CITY PLANNING COMMISSION

APPLICANT	Morton & Pitalo, Inc 1767 "J" Tribute Rd., Sacramento, Ca. 95815				
OWNER	Johan Lindstrom, 80 Lynwood Place, Moraga, Ca. 94556				
PLANS BY	Morton & Pitalo, Inc.				
FILING DATE	7-22-83	50 DAY CPC ACTION DATE		REPORT BY:	TM:mm
NEGATIVE DEC	8-5-83	EIR		ASSESSOR'S PCL NO.	117-012-18

- APPLICATION:
1. Negative Declaration
 2. General Plan Amendment from Commercial /Office to Residential
 3. Community Plan Amendment from Shopping/Commercial to Medium Density Residential
 4. Rezone from C-2 (PUD) to R-3 (PUD)
 5. Amendment of Valley Hi Centrum PUD Schematic Plan
 6. Special Permit for 211 condominium units
 7. Subdivision Modification to waive sewer and water service connections.
 8. Tentative Map (P83-244)

PROPOSAL: The applicant is requesting the necessary land use entitlements to develop 211 airspace condominium units

Exhibit "A" Schematic PLAN

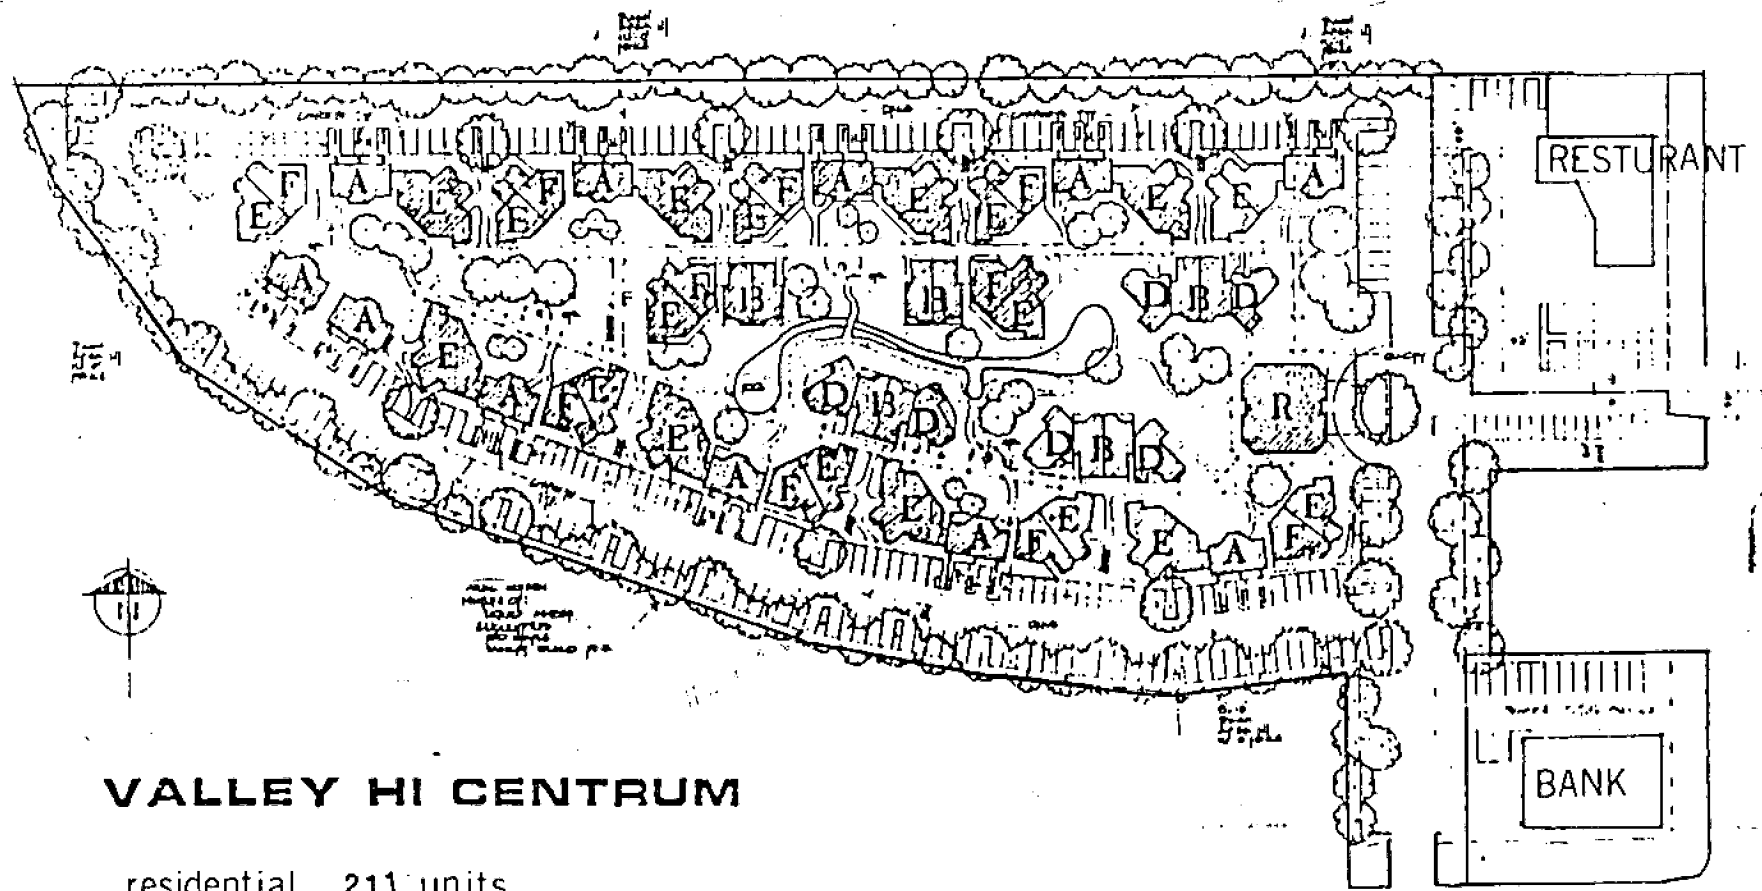
The proposed Schematic Plan amendment would eliminate the designated offices but would retain the commercial uses along Valley Hi Drive.

The Subdivision Review Committee, based upon the City Traffic Engineer's input, recommends that the proposed access onto Valley Hi Drive be relocated to the north so as to align with an existing median break. Staff notes that this realignment will necessitate minor revisions to the schematic plan.

- f. Provide private access easements between the proposed parcels as required by the City Traffic Engineer;
- g. Relocate the proposed access onto Valley Hi Drive to align with the driveway on the east side of the street.
